**FINAL DRAINAGE REPORT  
FOR  
MVEA YODER ELECTRIC SUBSTATION  
EL PASO COUNTY, COLORADO**

**AUGUST 2018**

Job No. 1802.00

# DEVELOPED DRAINAGE MAP

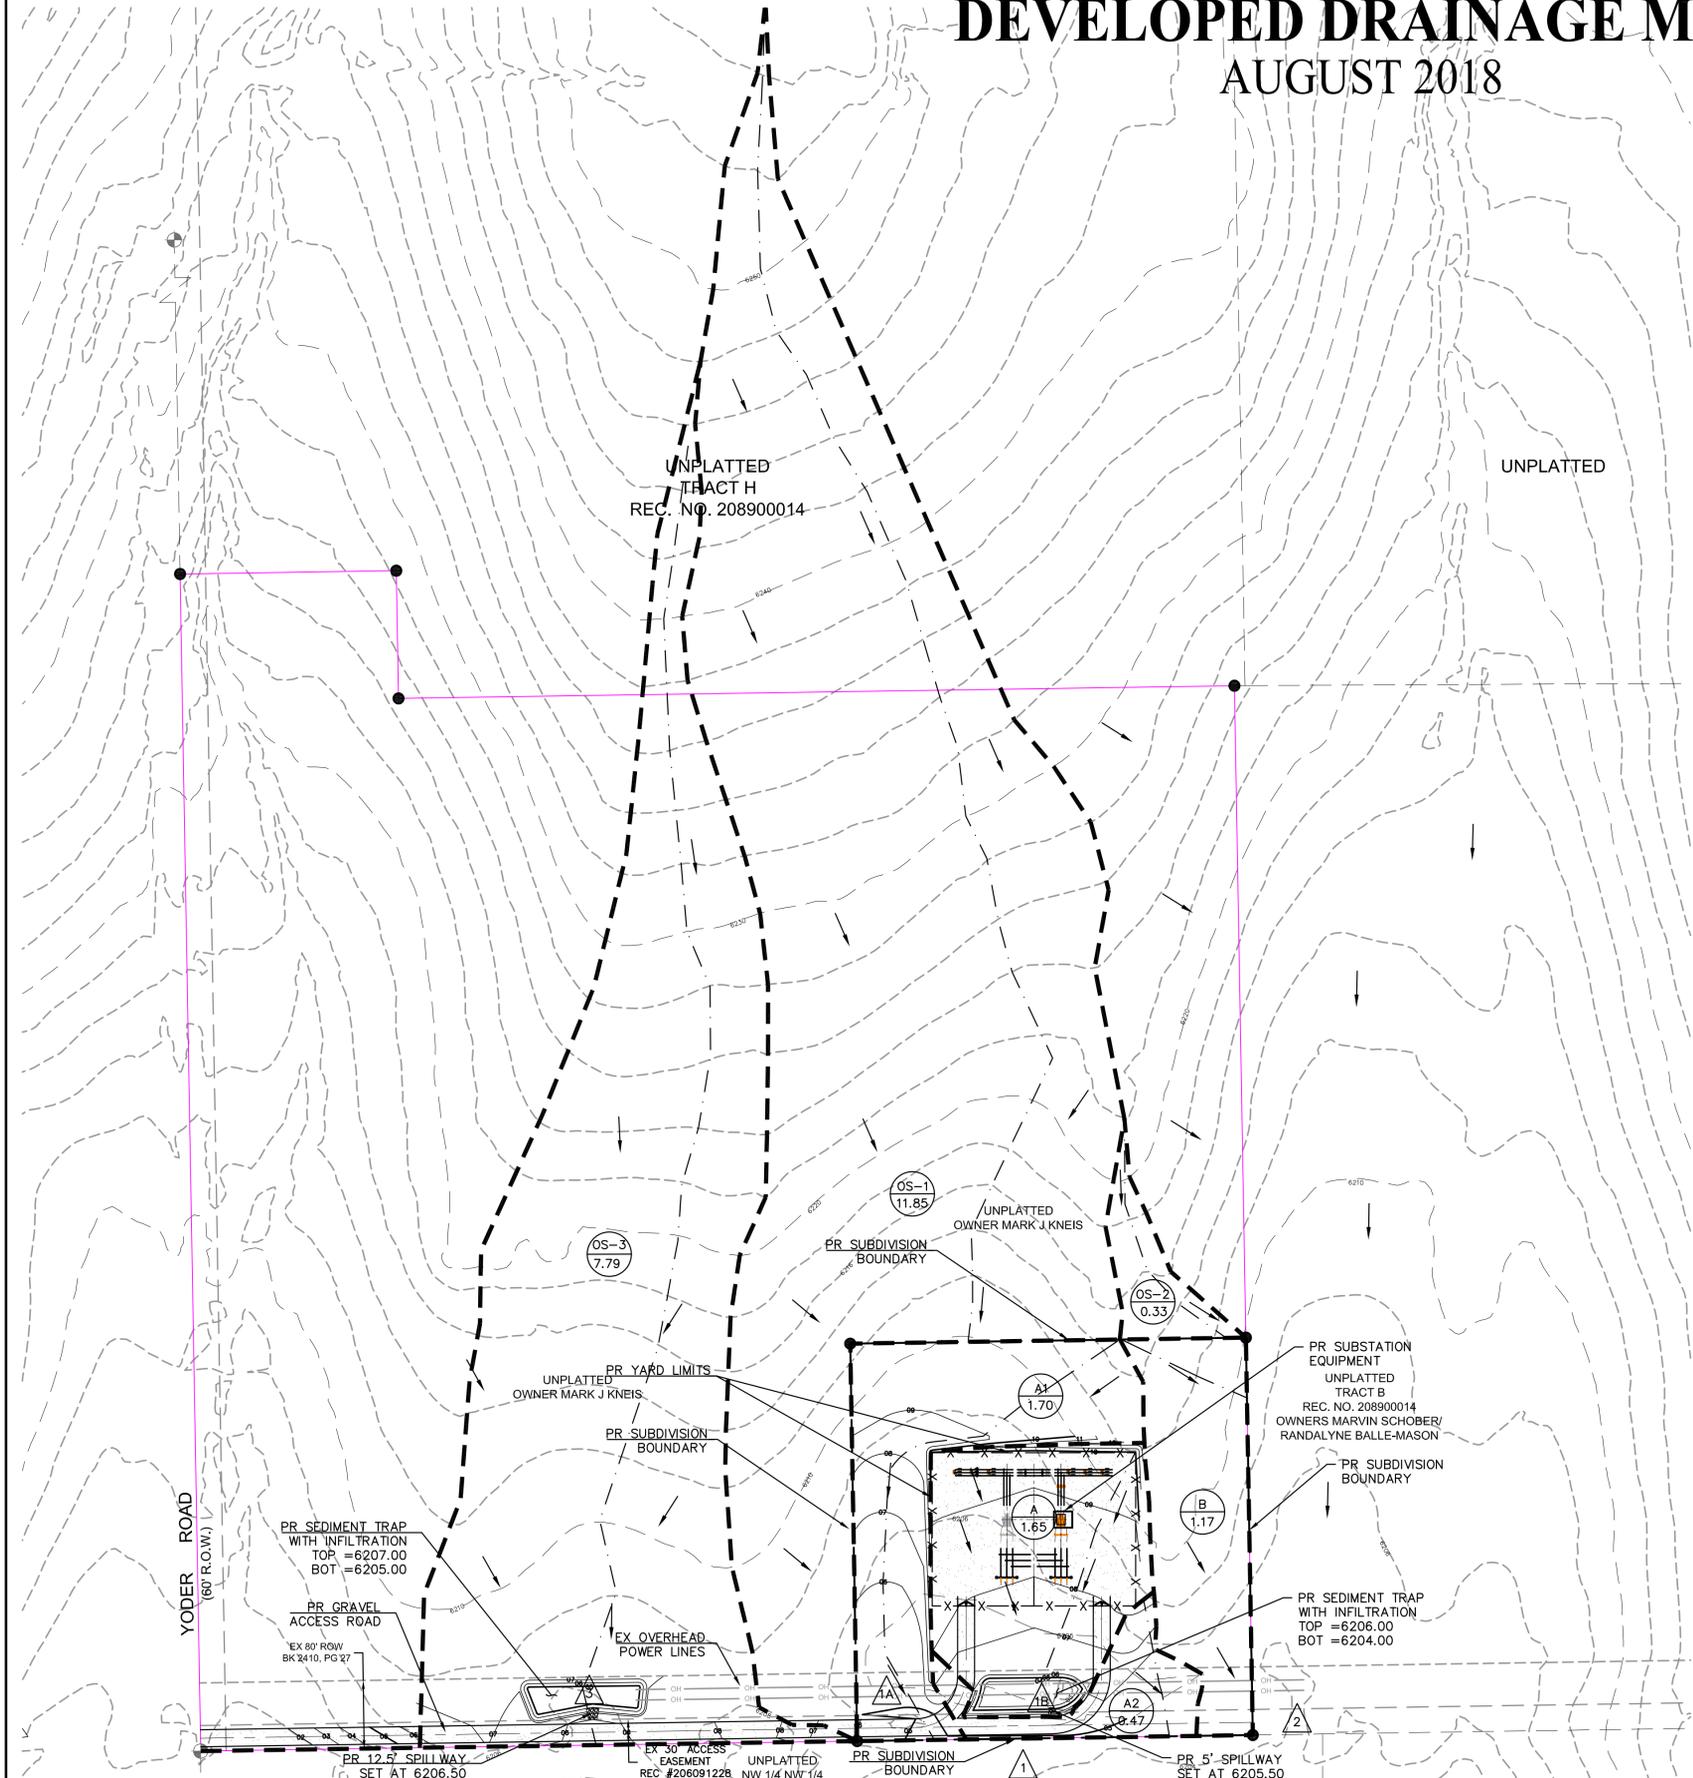
Include design points 1B and 3

# EXISTING DRAINAGE MAP

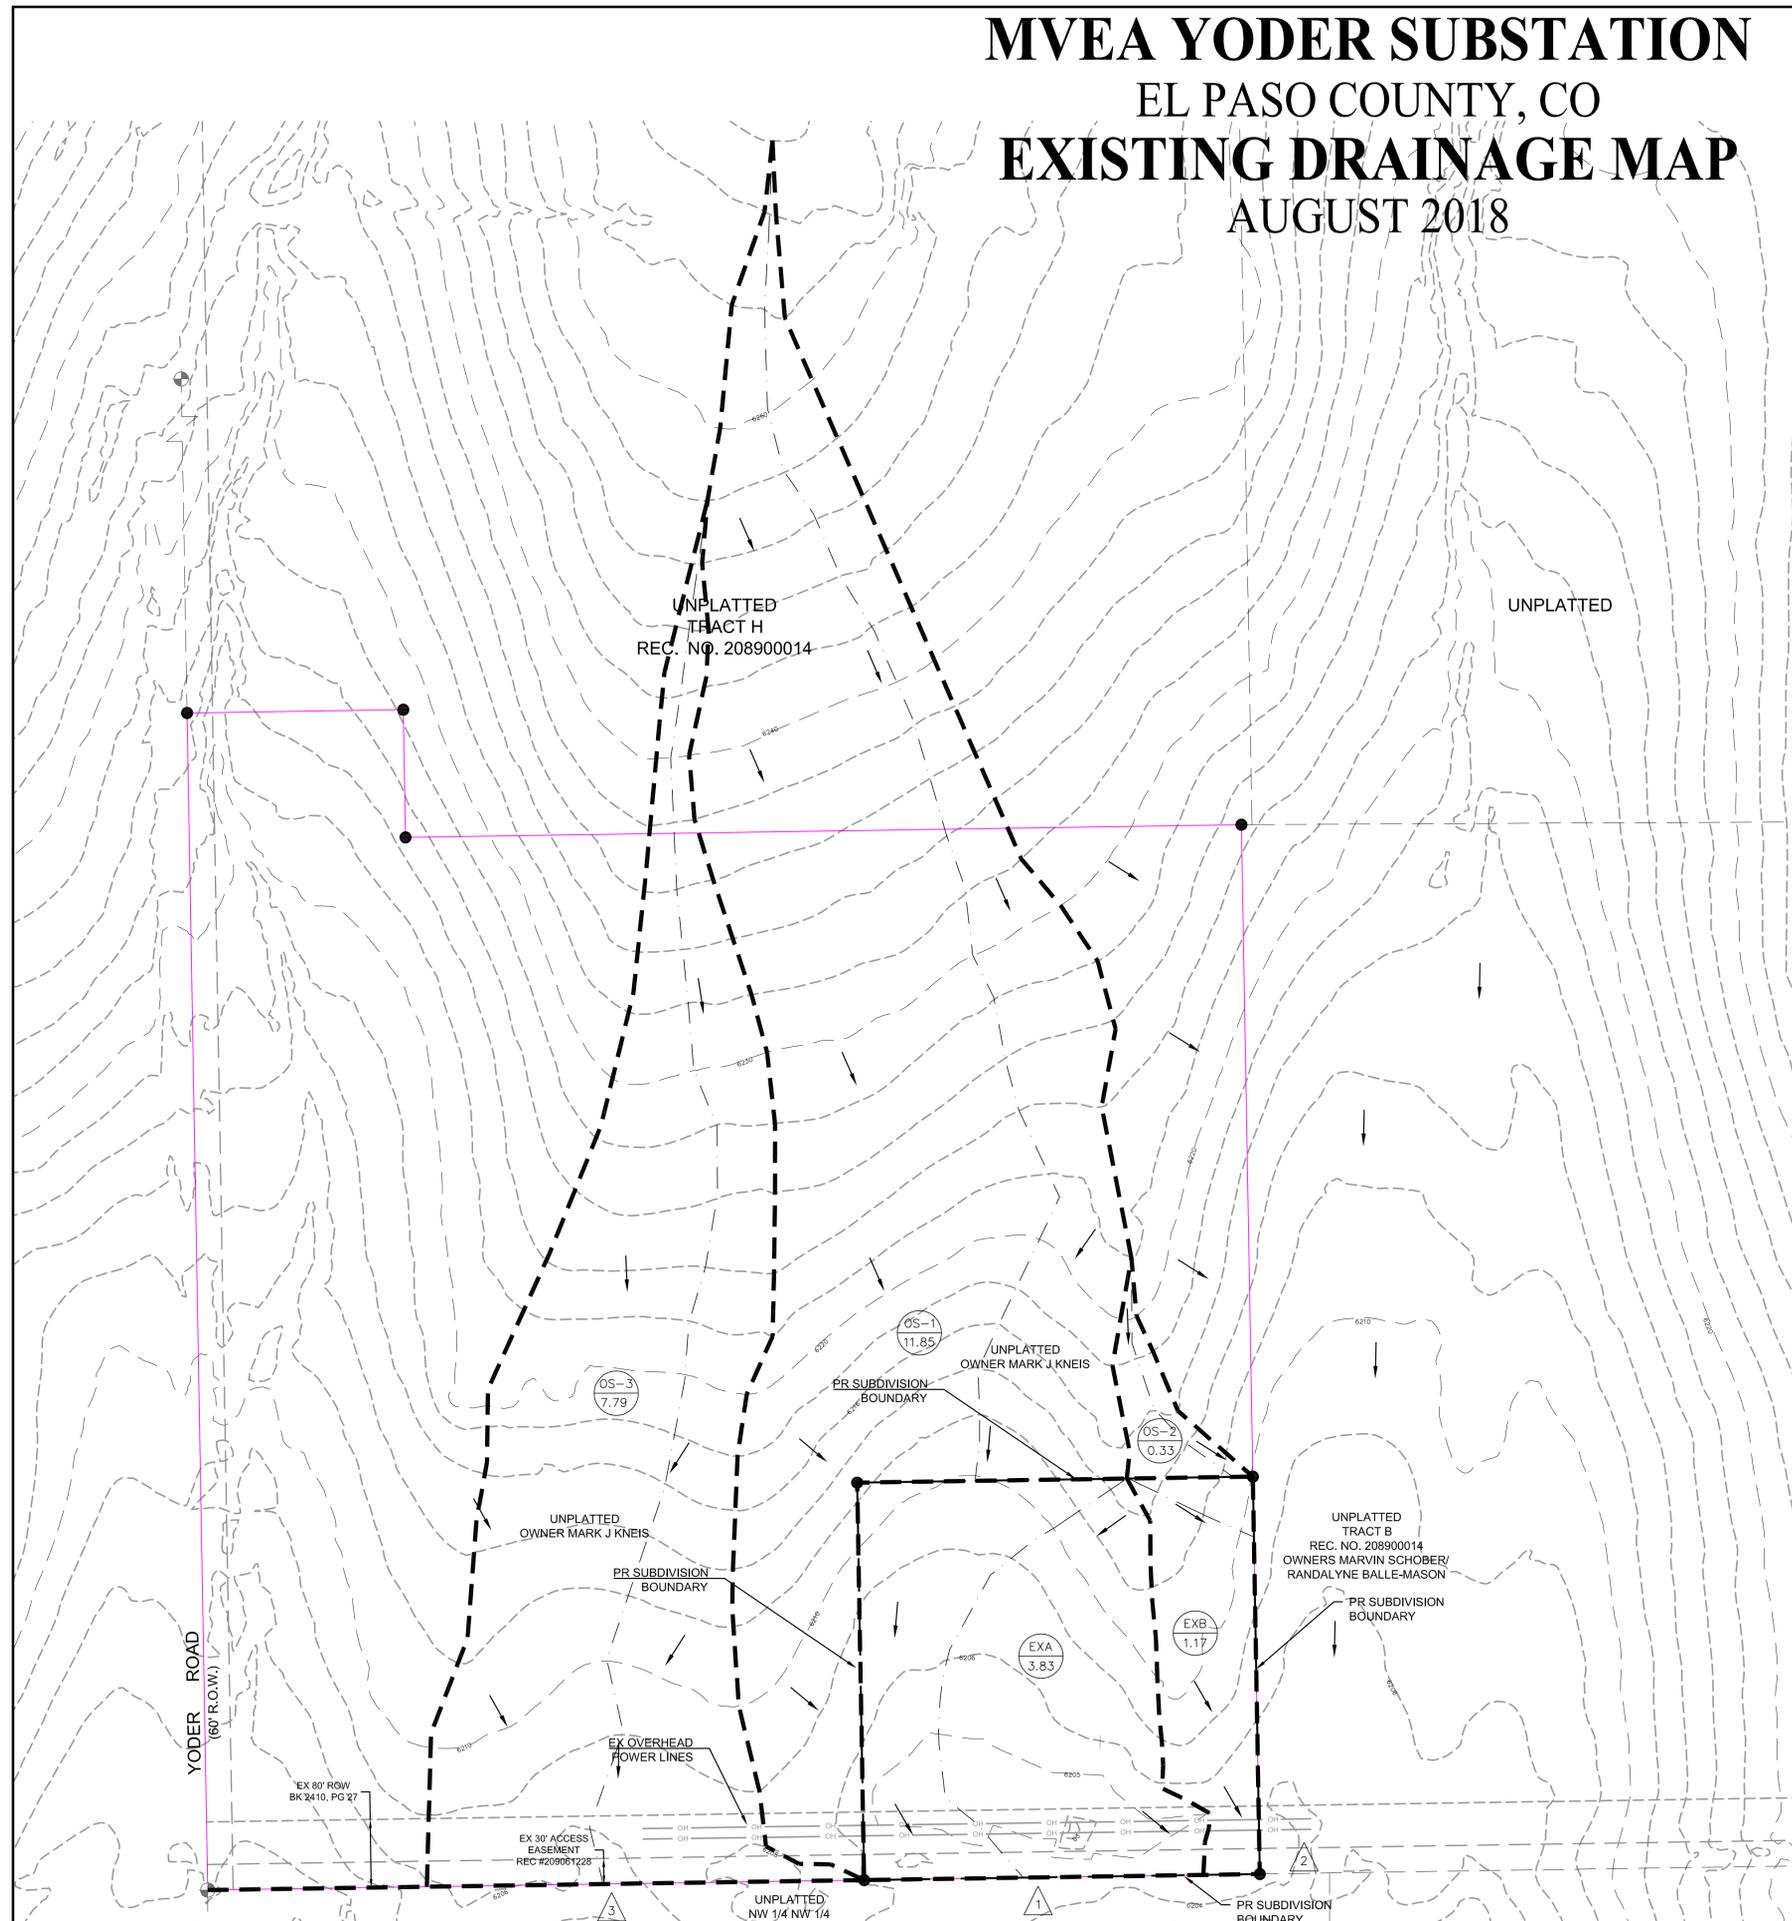
This is the existing drainage map, so existing conditions should be shown.
